Review of the Bipole III EIS - Wildlife

Douglas L. Skinner, M.Sc., P.Biol.

Impact Definitions

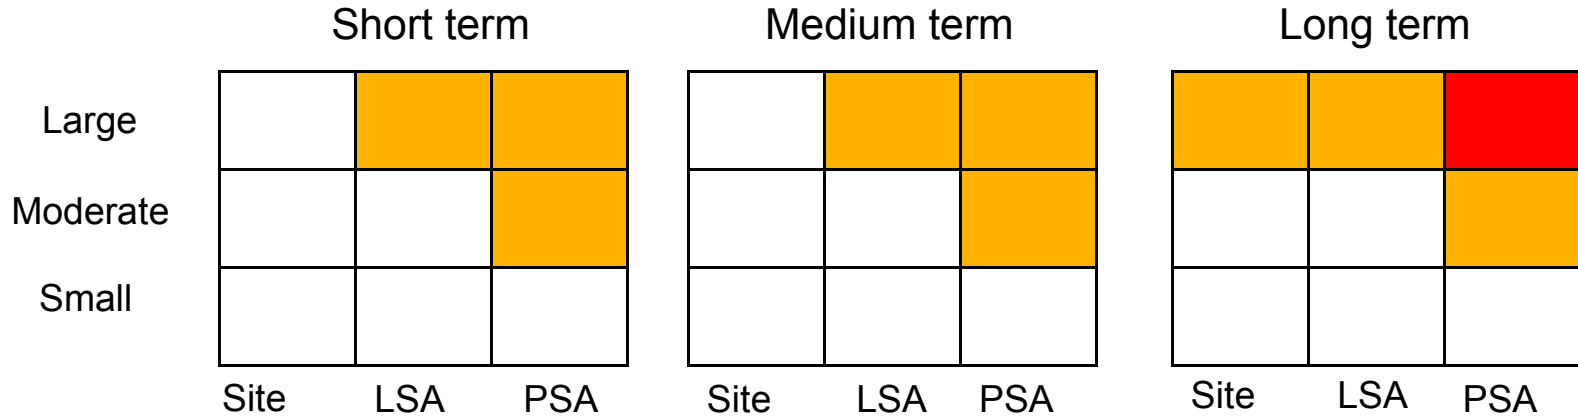
Important Points

- Probability of a *significant* impact = 4% (1/27)
- Probability of a *potentially significant* impact = 33% (9/27)
- Probability of a *not significant* impact = 63% (17/27)
- Only long-term impacts (>50 yr) are *significant*
